**DOCUMENT 00 91 03  
ADDENDUM NO. 3**

PROJECT: 2024 Smith and Spillane MS Renovations  
BID DATE: **Thursday, February 20, 2025 (no Change)**  
FROM: Carolina Weitzman, A.I.A.  
Natex Corporation Architects  
447 Heights Blvd, Houston, TX 77007  
TO: **Prospective Bidders**

Project Number: 23073  
 Date: 26 JANUARY 2025  
 Drawn By: WHL / KLO  
**ELECTRICAL LIGHTING**  
**FIRST FLOOR PLAN -**  
**AREA 'B'**  
**E2.02**

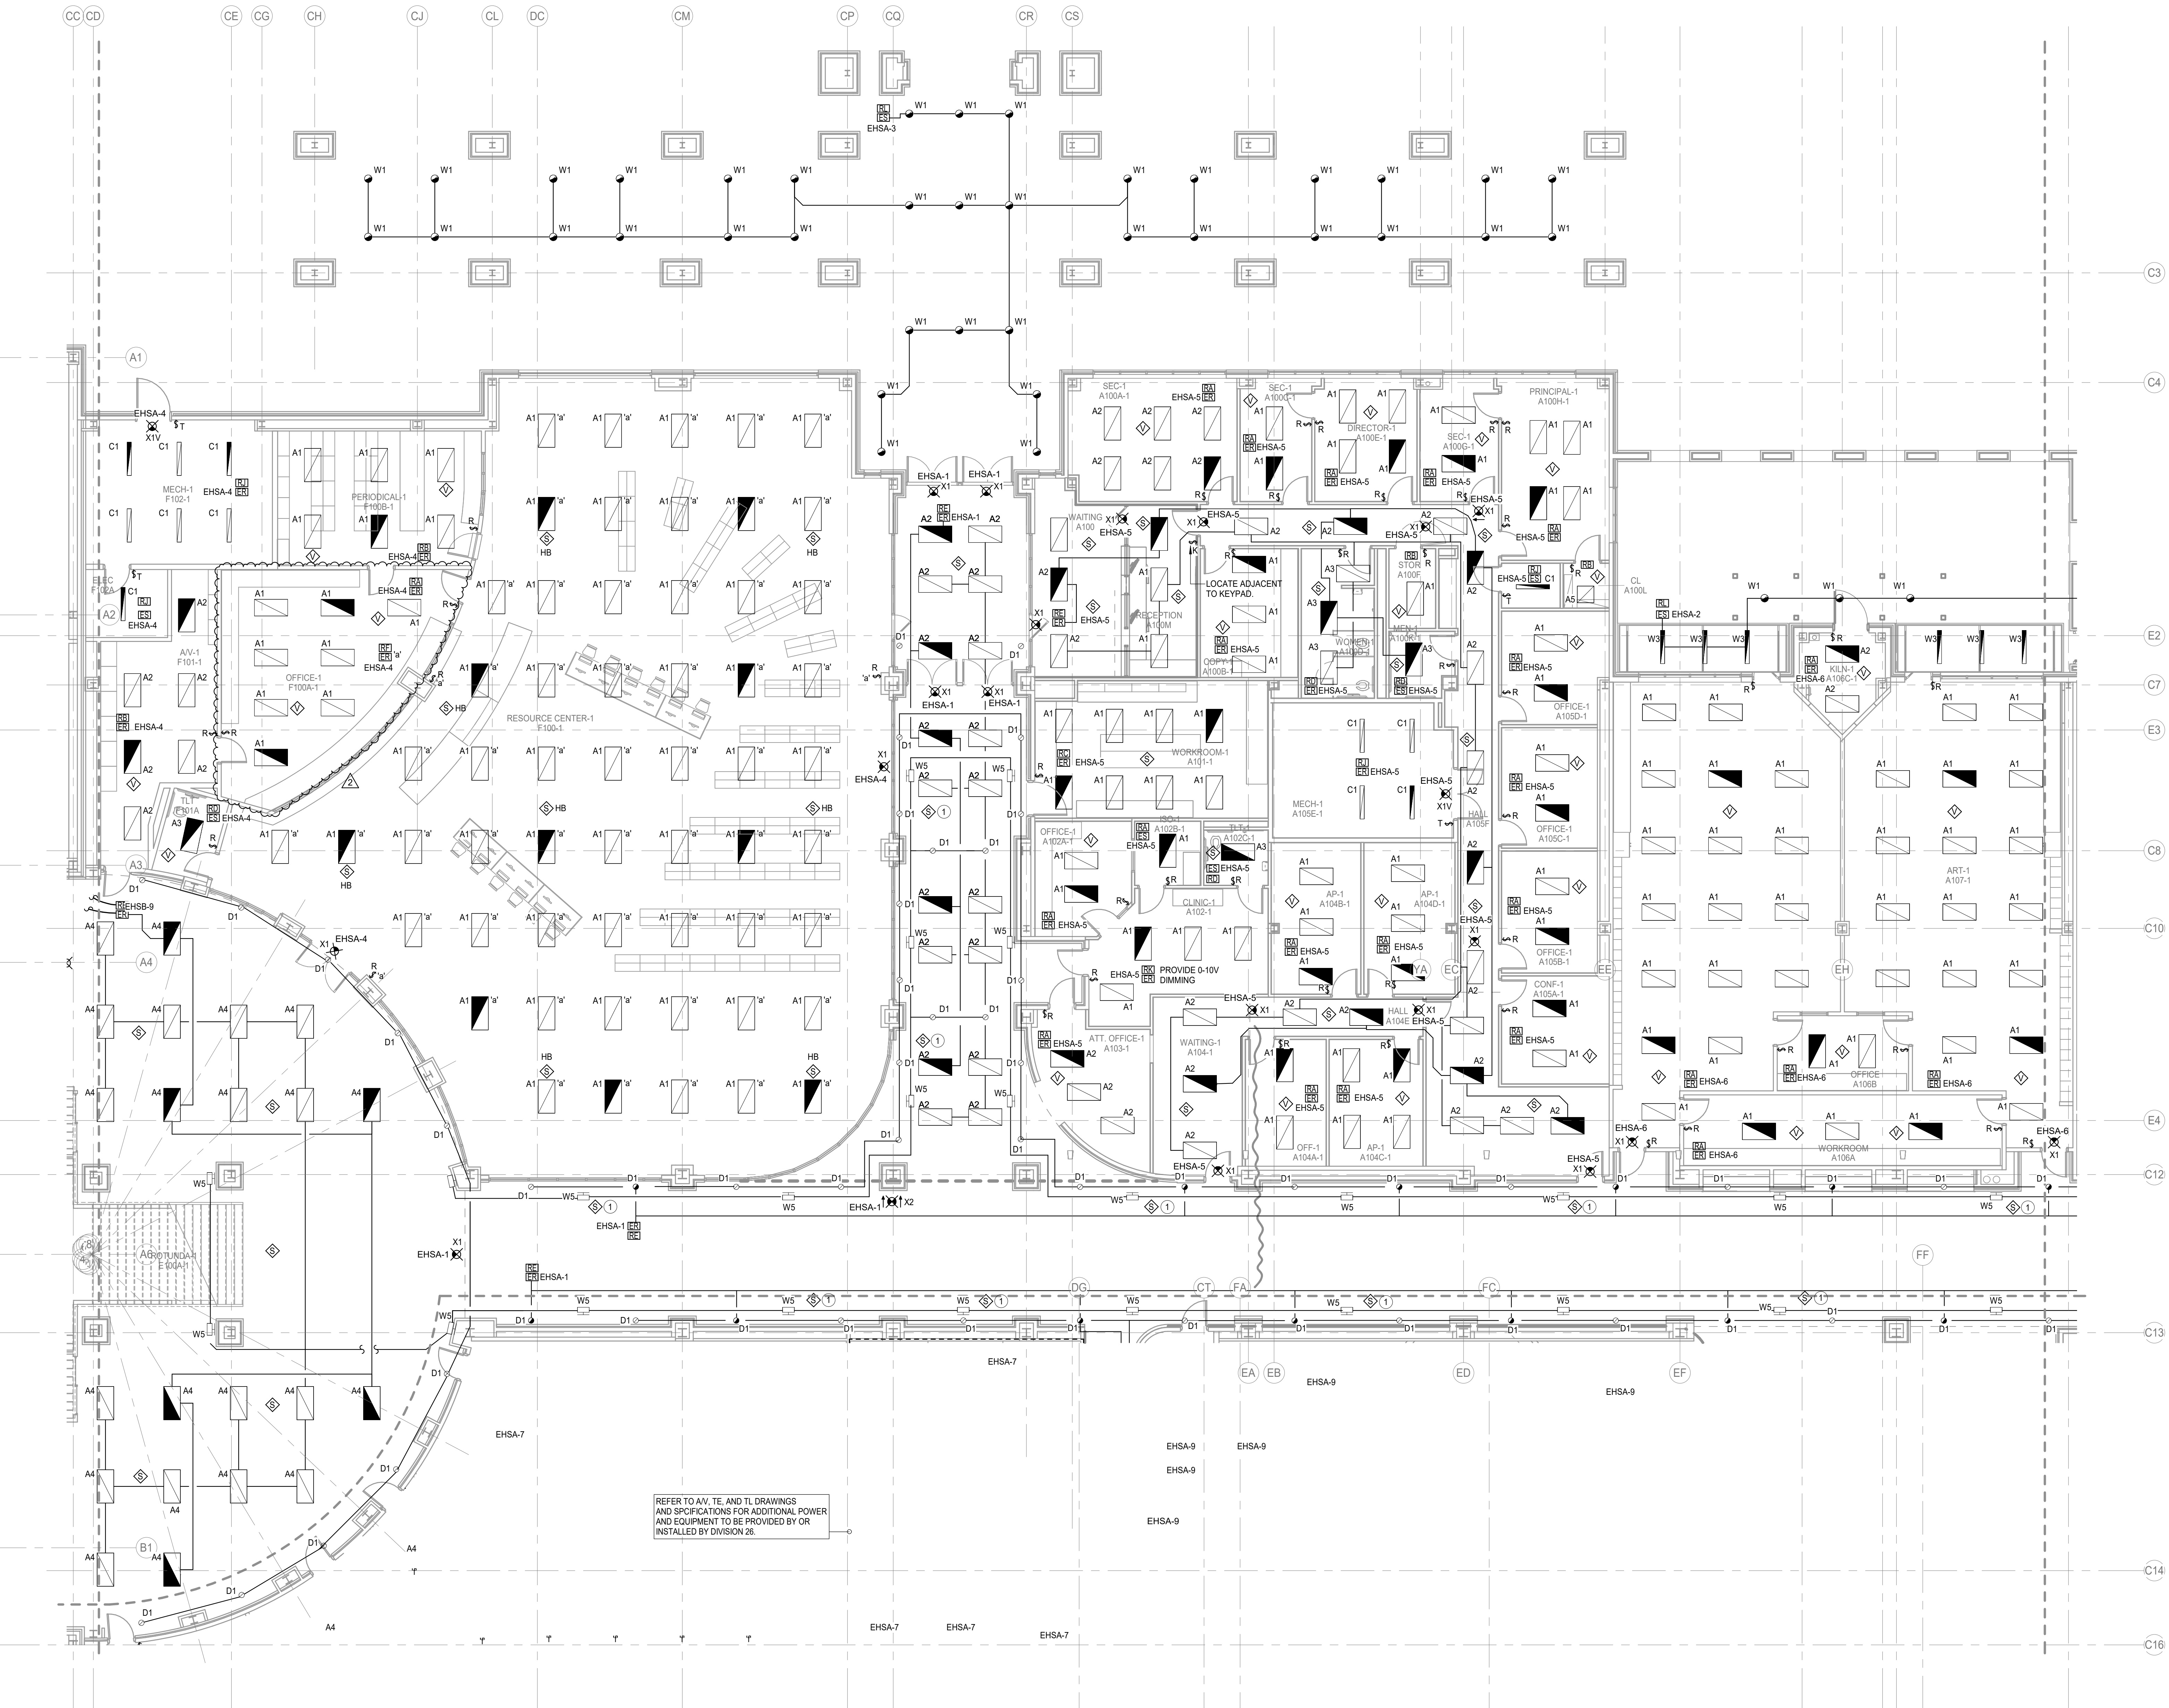
14. E2.01 - ELECTRICAL LIGHTING FIRST FLOOR PLAN -AREA 'A'
  - a. Lighting layout revisions as noted.
15. E2.02 - ELECTRICAL LIGHTING FIRST FLOOR PLAN -AREA 'B'

- a. Lighting layout revisions as noted.
16. E2.03 - ELECTRICAL LIGHTING FIRST FLOOR PLAN -AREA 'C'
  - a. Lighting layout revisions as noted.
17. E2.04 - ELECTRICAL LIGHTING FIRST FLOOR PLAN -AREA 'D'

Project Number: 23073  
 Date: 26 JANUARY 2025  
 Drawn By: WHL / KLO  
 Electrical Lighting  
 FIRST FLOOR PLAN - AREA 'C'  
**E2.03**

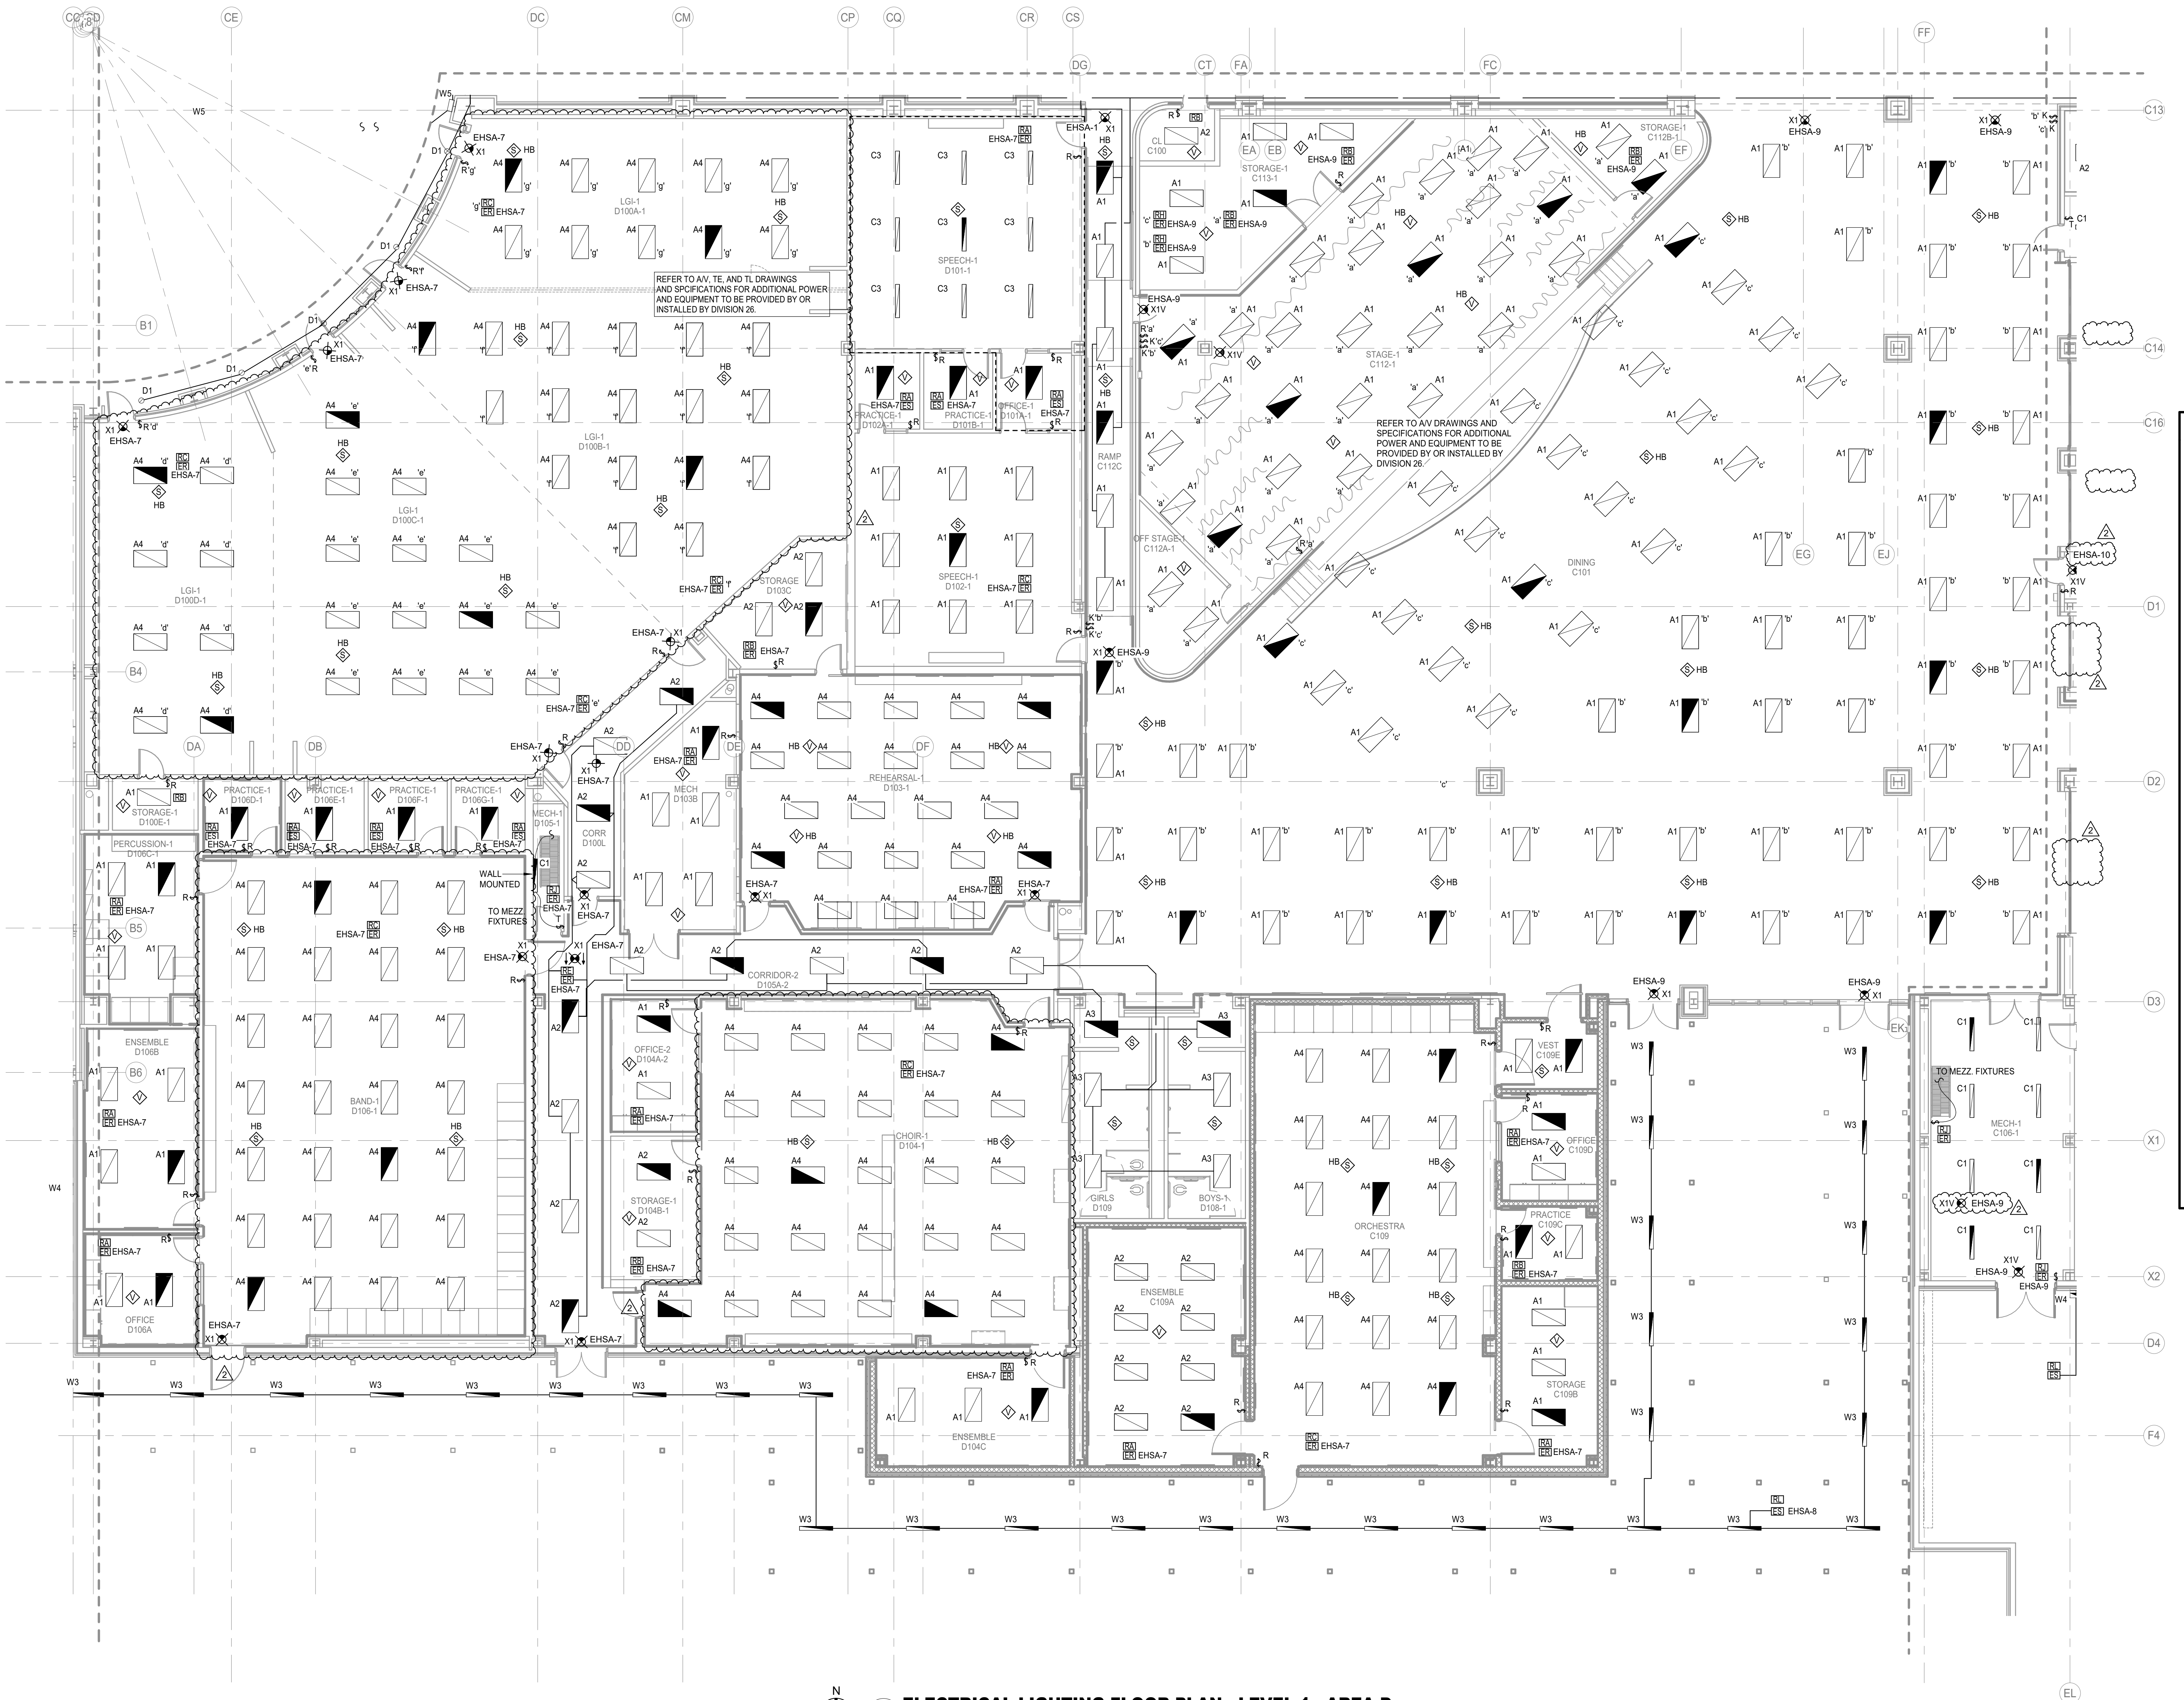
- a. Lighting layout revisions as noted.
18. E2.06 - ELECTRICAL LIGHTING FIRST FLOOR PLAN -AREA 'F'
  - a. Lighting layout revisions as noted.
19. E2.08 - ELECTRICAL LIGHTING FIRST FLOOR PLAN -AREA 'H'
